ADDENDUM NO. 1

This addendum includes Item Number 1-1 thru 1-76. This addendum item shall be fully incorporated into the Bidding/Contract Documents and have the same force and effect as though originally included.

Life Sciences Collaboration
1910 N. Antelope Valley Parkway
Lincoln, Nebraska
TCEP No.: 716-002-12
Davis Design.: 12-0077
BVH No.: L12018.unl
November 27, 2013

**Item 1-25: Sheet AR3.03 – IAB-Exterior Elevations
Sheet AR3.04 – IAB-Exterior Elevations**

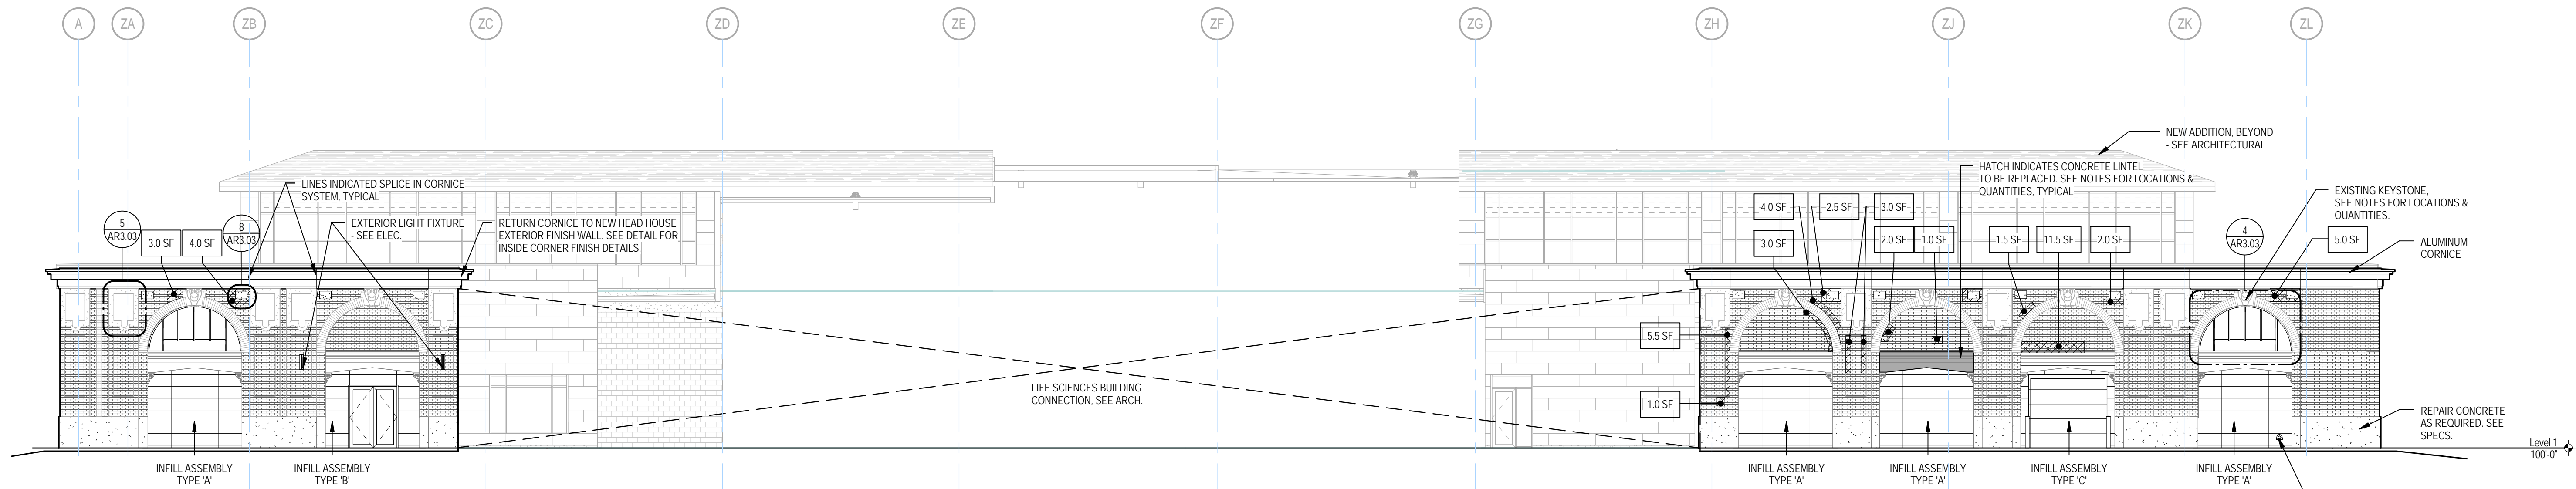
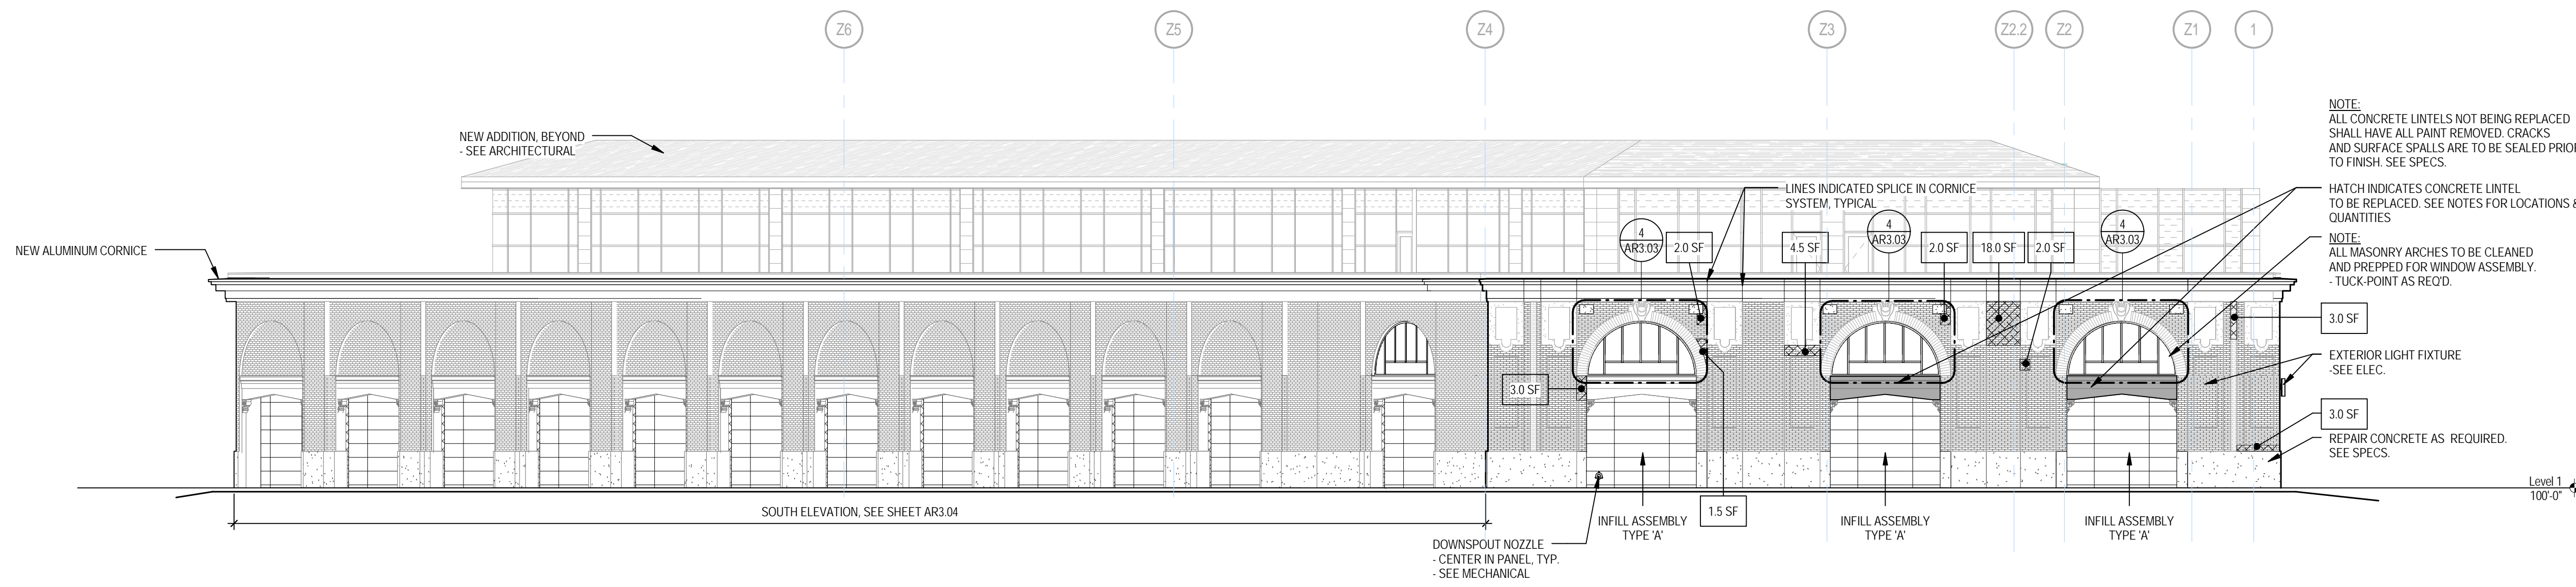
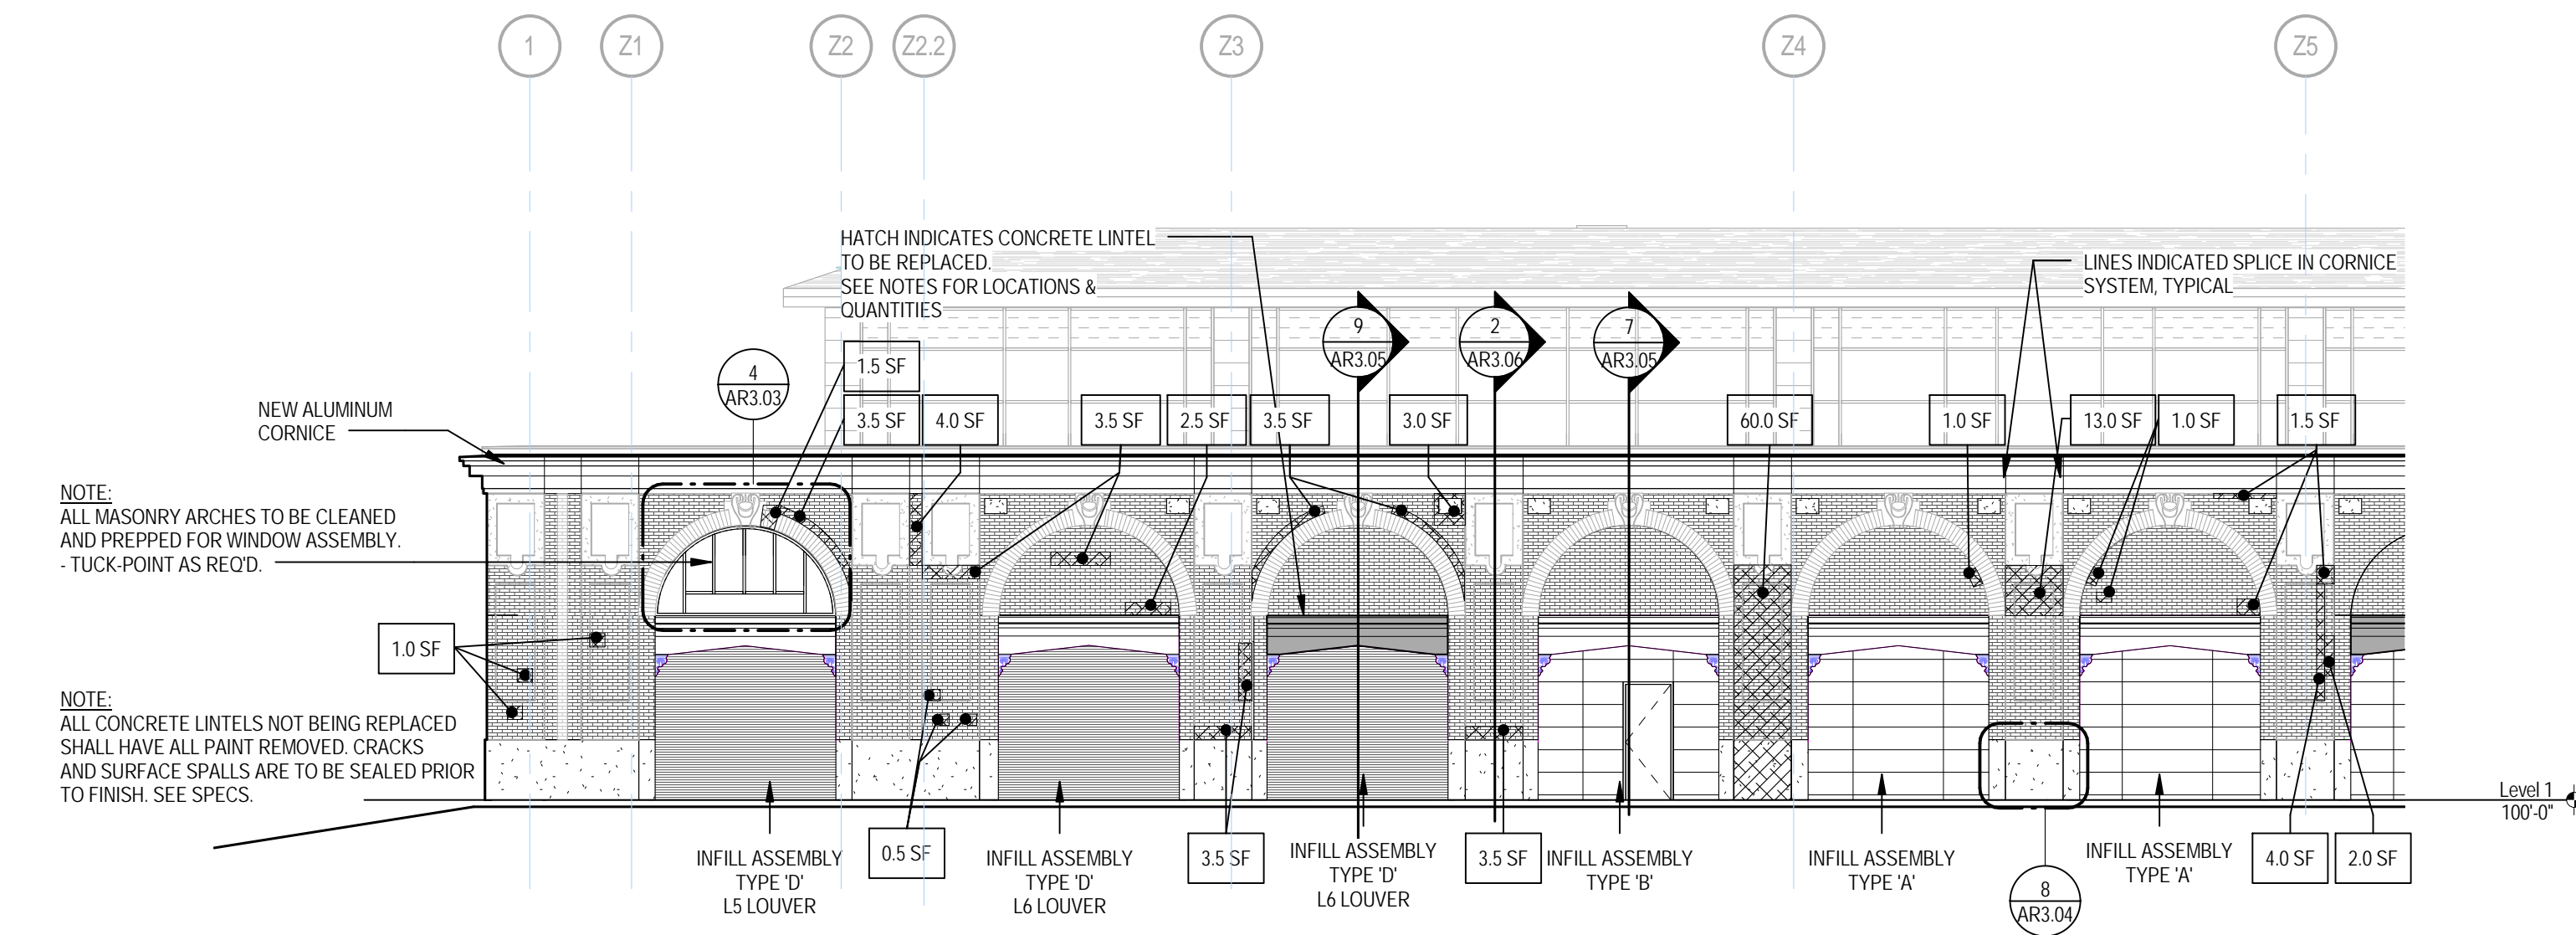
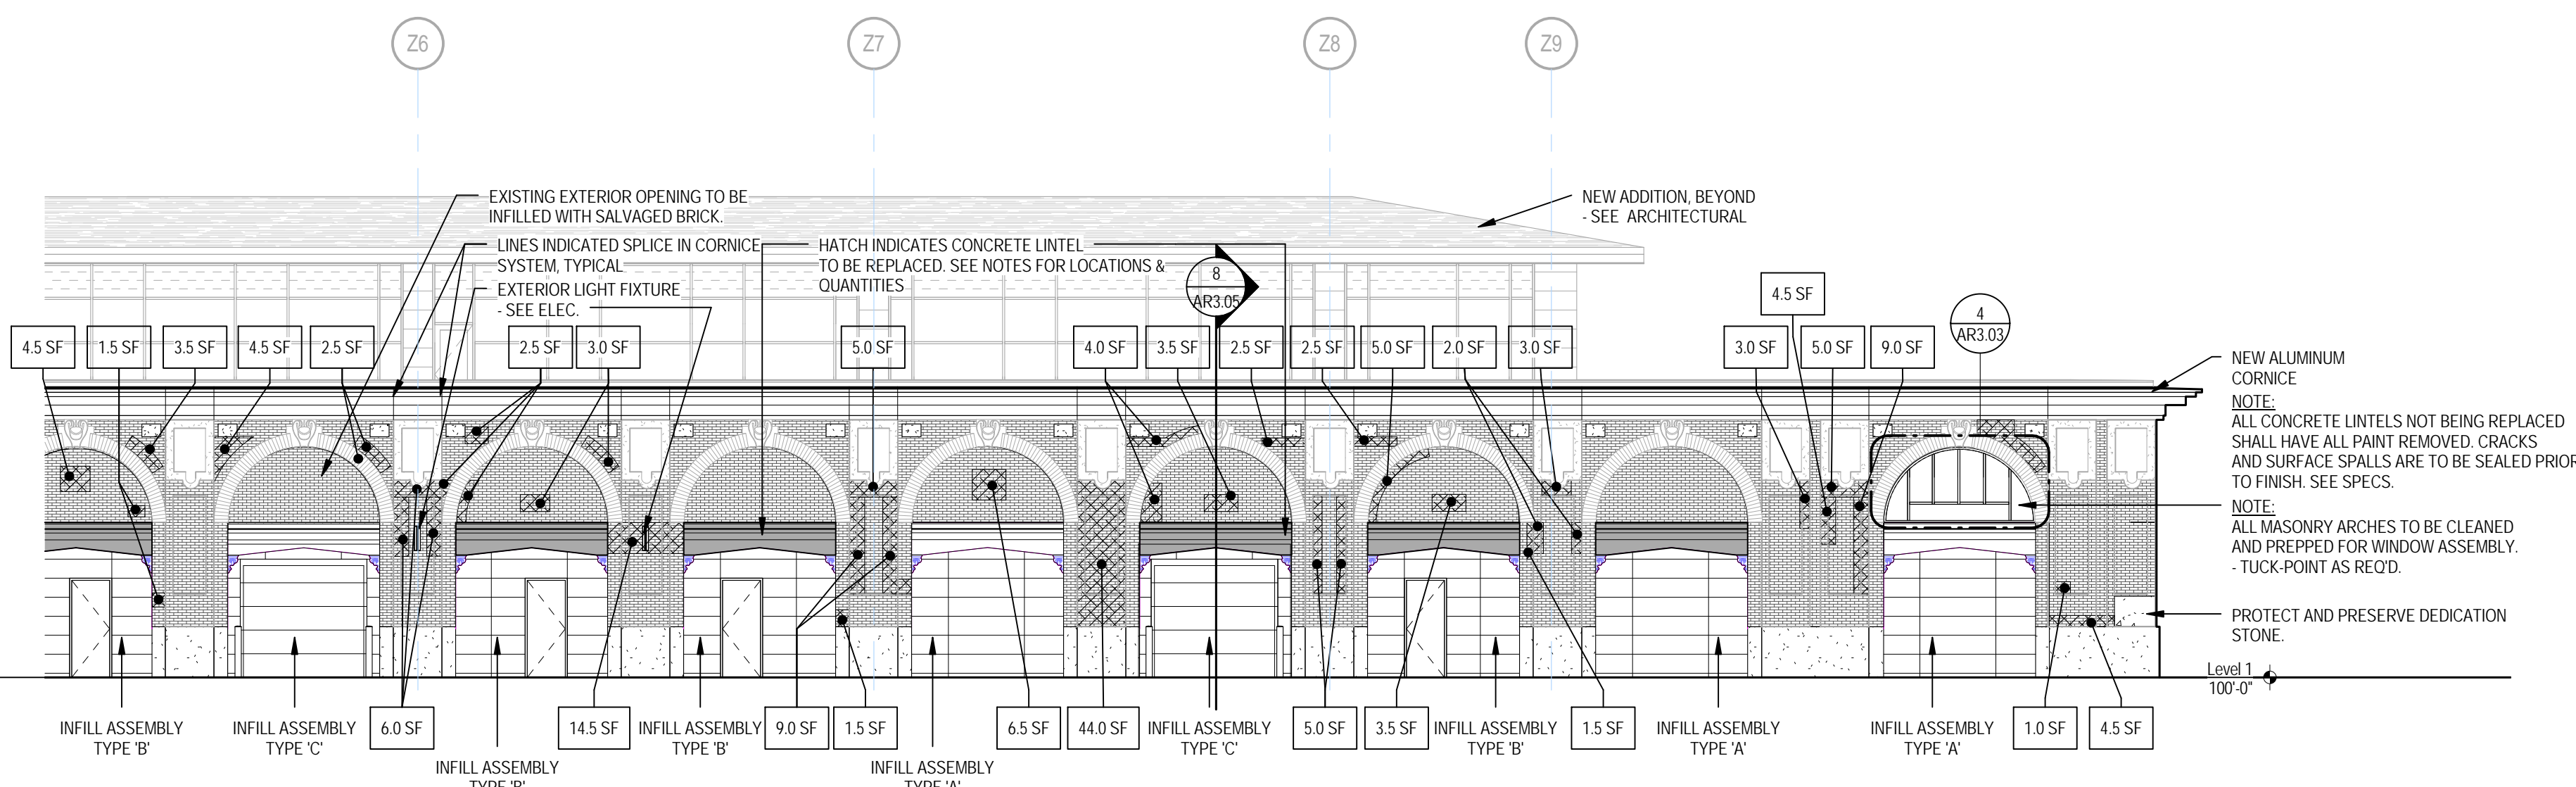
Add details 14 & 15, see attached updated sheet. Details shall apply to existing lintels that are designated to be replaced on sheets AR3.02 & AR3.03
